IECC - Commercial

2016 GROUP B PUBLIC COMMENT AGENDA

OCTOBER 19 - OCTOBER 25, 2016
KANSAS CITY CONVENTION CENTER
KANSAS CITY, MO

TABLE C301.1

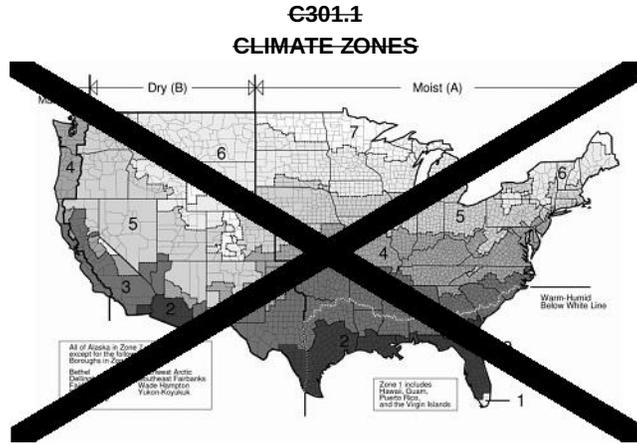
Delete without substitution:

FIGURE C301.1
United States Climate Zones

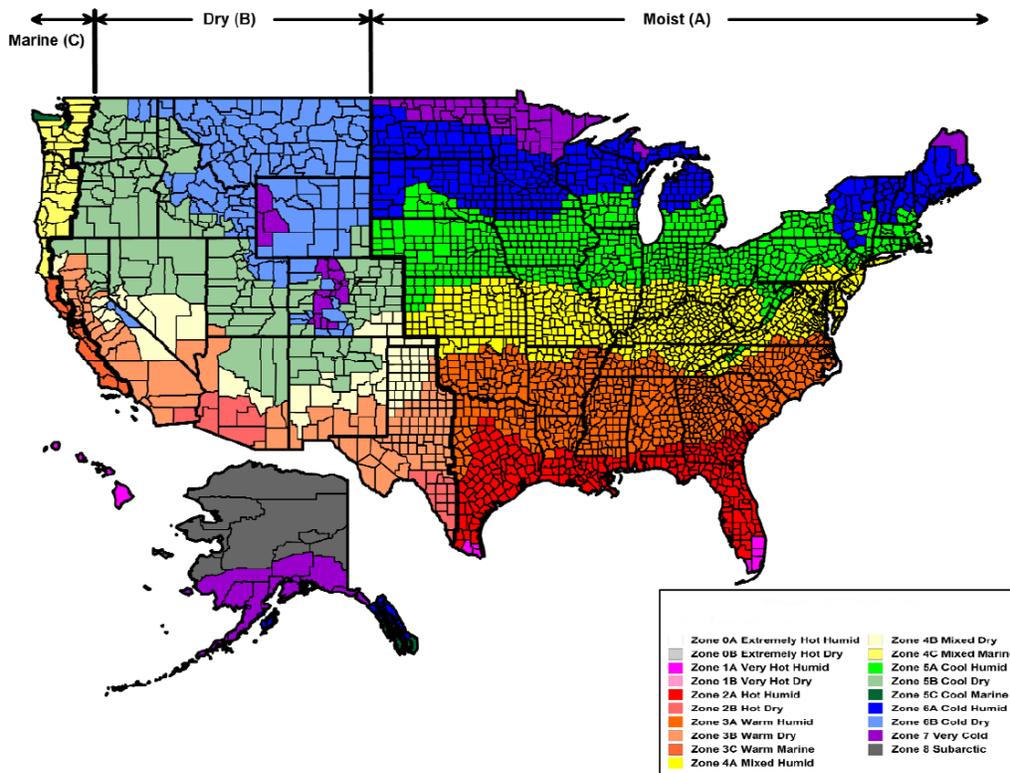
C301.1 General. *Climate zones* from Figure B-1 C301.1, Figure B-1of ASHRAE 169 or Table B-1 of ASHRAE 169 shall be used in determining the applicable requirements from Chapter 4. Locations not in Table B-1 (outside the United States) shall be assigned a *climate zone* based on Table A-5, Table A-6, or Section A3 including Table A-3 of ASHRAE 169.

**FIGURE C301.1
CLIMATE ZONES**

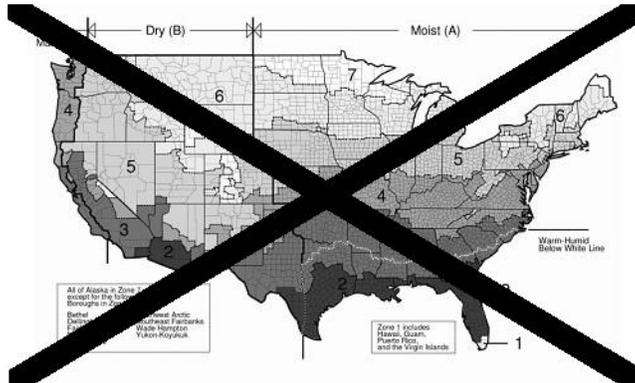
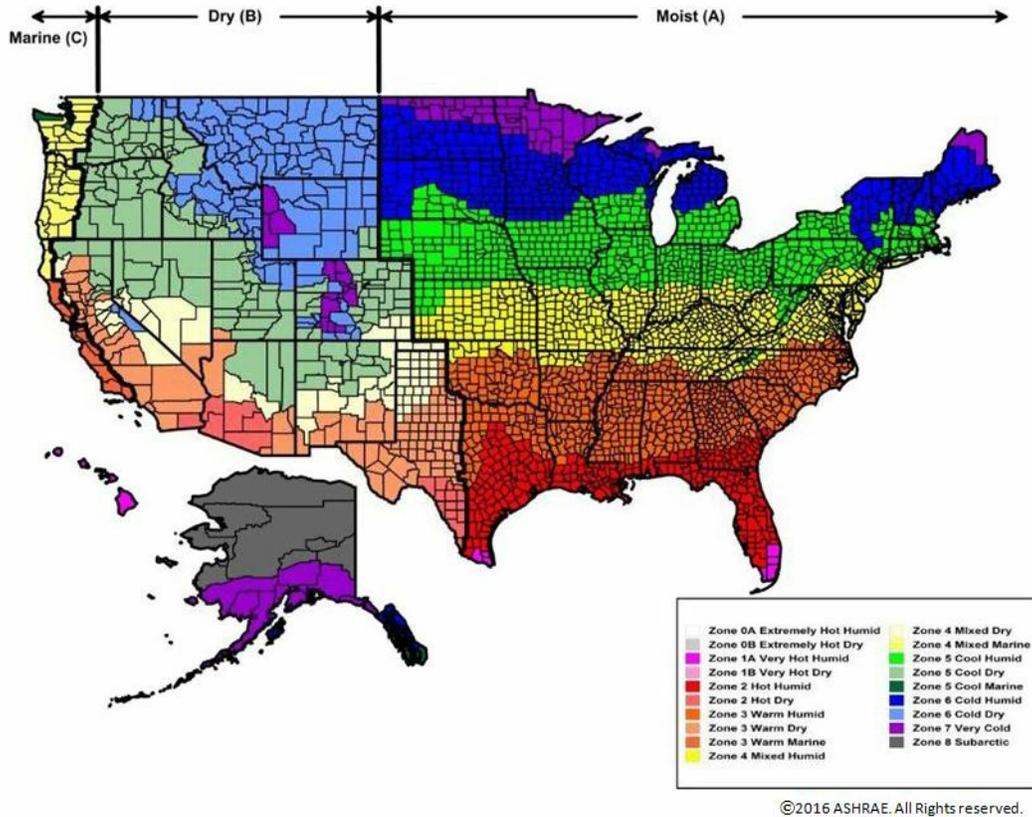
C301.1 General. *Climate zones* from Figure C301.1 (reprinted from Figure B-1 of ASHRAE 169) or Table C301.1 (reprinted from Table B-1 of ASHRAE 169) shall be used in determining the applicable requirements from Chapter 4. Locations not in Table B-1 (outside the United States) shall be assigned a *climate zone* based on Table A-5, Table A-5, Table A-6, or, if not listed in those tables, Section A3 including Table A-3 of ASHRAE 169.

Commenter's Reason: This modification includes the U.S. map as Figure C301.1 and U.S. county tables as Table C301.1 to be used in determining the climate zone for locations within the U.S. These were requested during testimony and from the committee at the hearings. Additional information is contained in the original reason statement.

FIGURE R301.1
United States Climate Zone Map

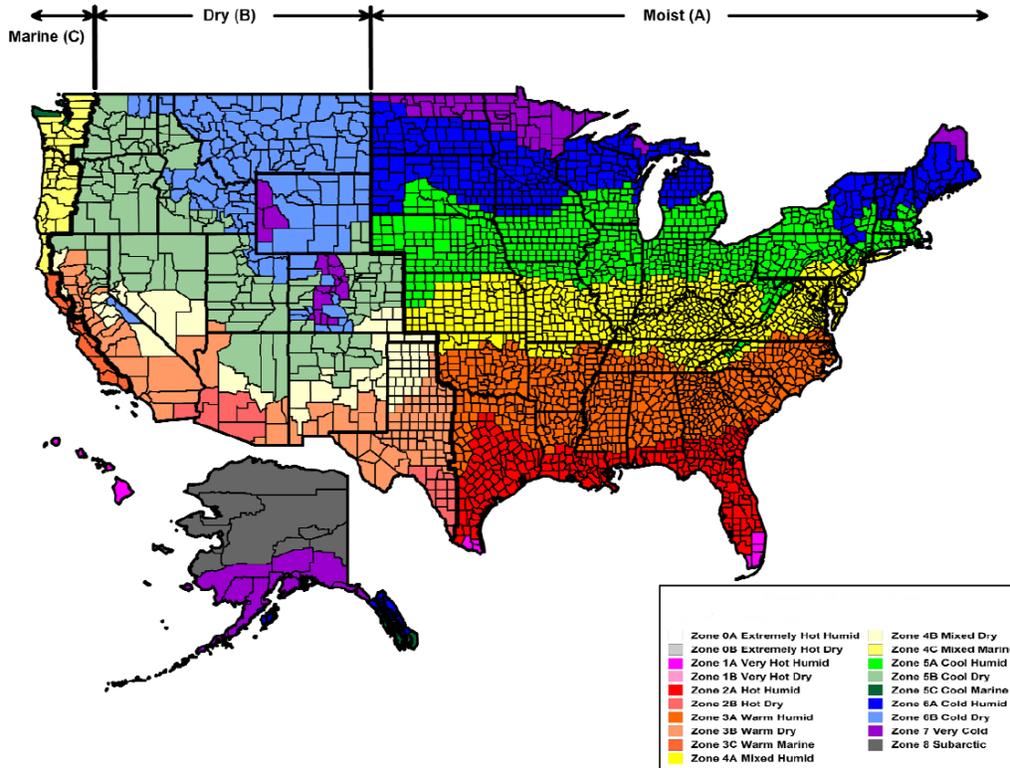
Modify as Follows:

**FIGURE R301.1(N1101.7)
CLIMATE ZONES**

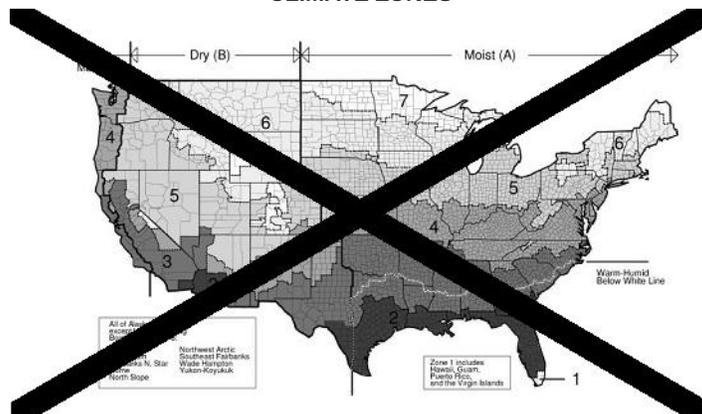
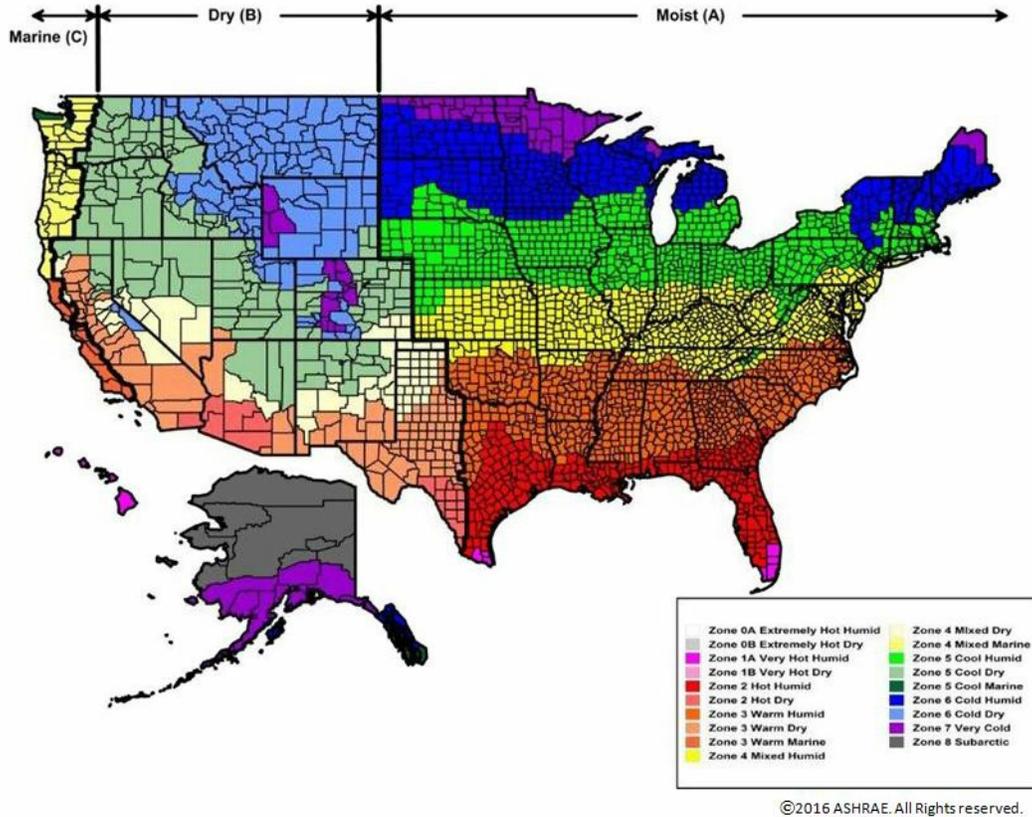
R301.1 (N1107.1) General. *Climate zones* from Figure B-1 or Table R301.1 (reprinted from Figure B-1 in ASHRAE 169-) or Table R301.1 (reprinted from Table B-1 in ASHRAE 169) shall be used in determining the applicable requirements from Chapter 4. Locations not in Table B-1 outside the United States shall be assigned a *climate zone* based on Table A-5, Table A-6, or if not listed in those tables, Section A3; including Table A-3, in of ASHRAE 169.

Commenter's Reason: This modification includes the U.S. map as Figure R301.1 and U.S. county table as Table R301.1 to be used in determining the climate zone for locations within the U.S. These were requested during testimony and from the committee at the hearings. Additional information is contained in the original reason statement. Clarifications were made on using ASHRAE 169 for international locations. Simple tables no longer exist for determining climate zone by weather data for a particular location, so the procedure in ASHRAE 169 has been referenced. The county tables are in a format of "replace proposal as follows". It shows the changes to the Climate Zones in Table R301.1 compared to the 2015 IECC rather than showing the changes relative to the public comment, which deleted Table R301.1. We did this with permission of IECC staff for clarification purposes.

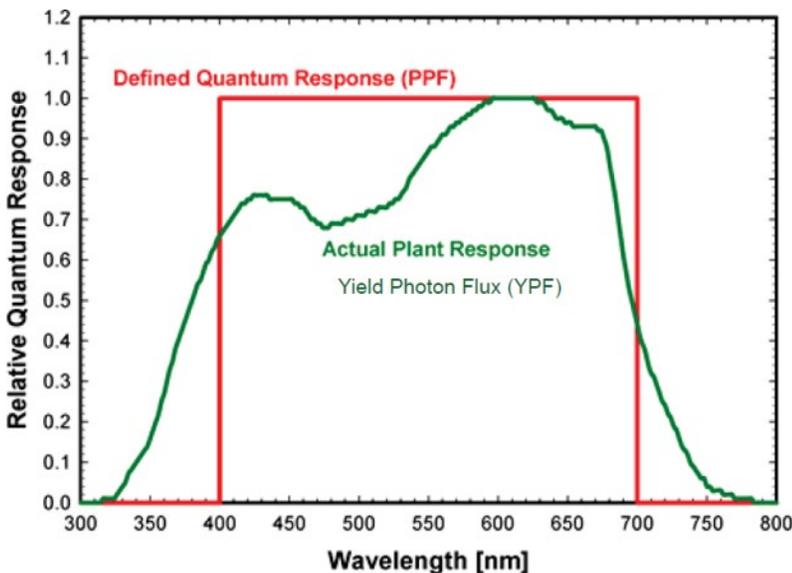
Commenter's Reason: At the Louisville hearings, the proponents found intense interest in the proposal but also heard several concerns with the specific requirements. This Public Comment addresses those specific concerns listed below and simplifies the main requirement as follows:

Not less than 95 percent of the permanently installed lighting fixtures used for plant growth and maintenance shall have a photon efficiency of not less than 1.6 $\mu\text{mol}/\text{J}$.

Figure 2. End-use cost for buildings in all U.S. climate zones

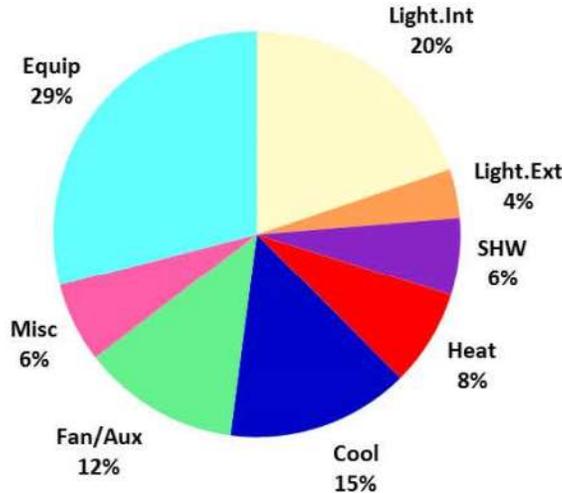
Based on a report from the U.S. Department of Energy's Pacific Northwest National Laboratory, office equipment is one of the highest energy costs in typical buildings representing 29% of the total cost on a building (see link to report and also Figure 2).

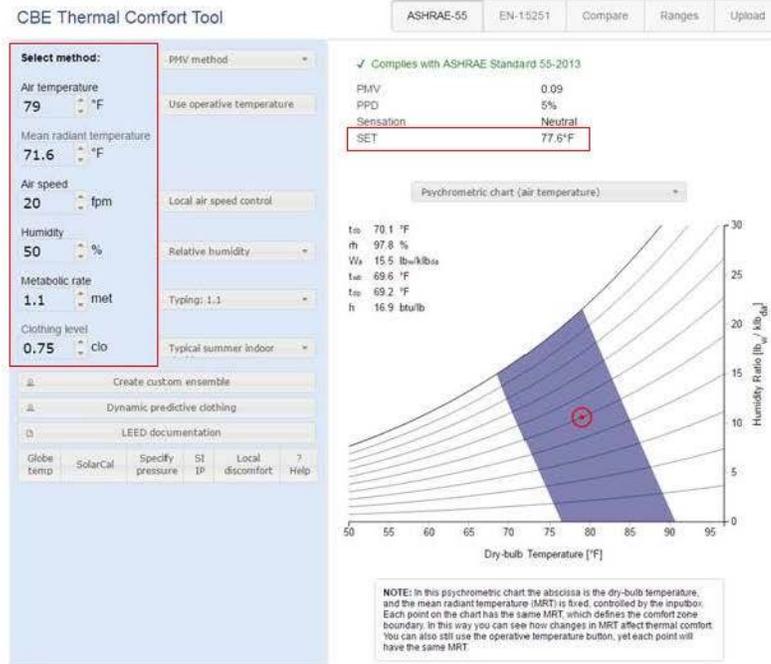
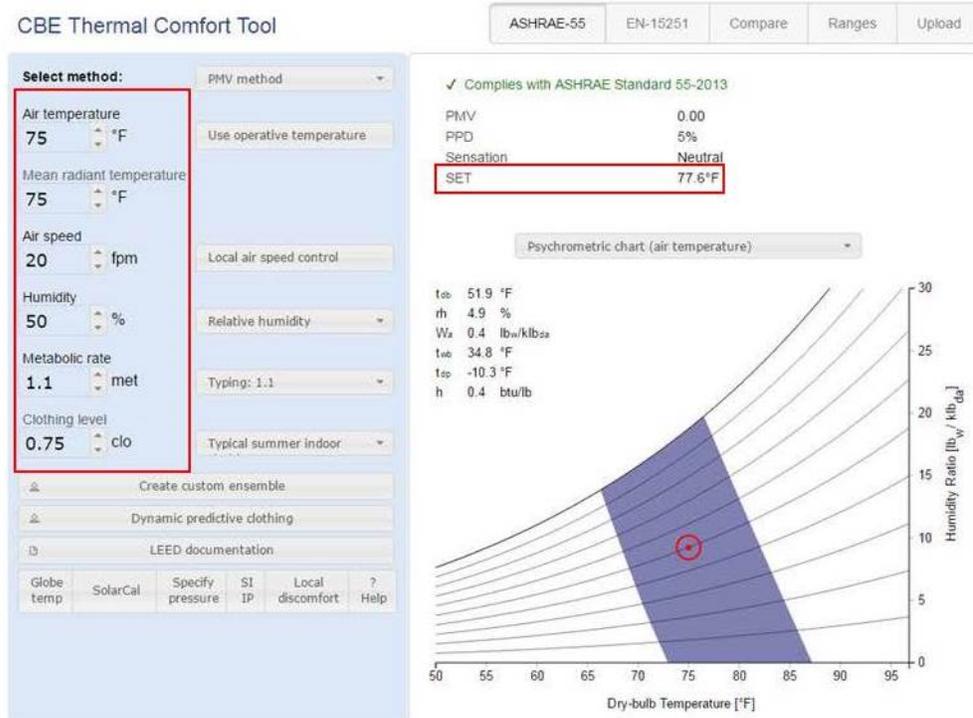
The required documentation for enforcement can be obtained using software such as the ASHRAE Thermal Comfort Tool or the CBE Thermal Comfort Tool. The CBE tool is a free, web based software program available from the University of California Berkeley. The comfort conditions for the are calculated for the Proposed Design, based on the design conditions in the proposed building.

The conditions for the standard reference design would be based on a standard HVAC system. The dry bulb temperature and mean radiant temperature would be set equal, and the temperature would be increased or decreased until the same Standard Effective Temperature (SET) was equal to that in the proposed design.

For this example, the Standard Reference Design would be simulated with the HVAC maintaining 75F and 50% relative humidity.
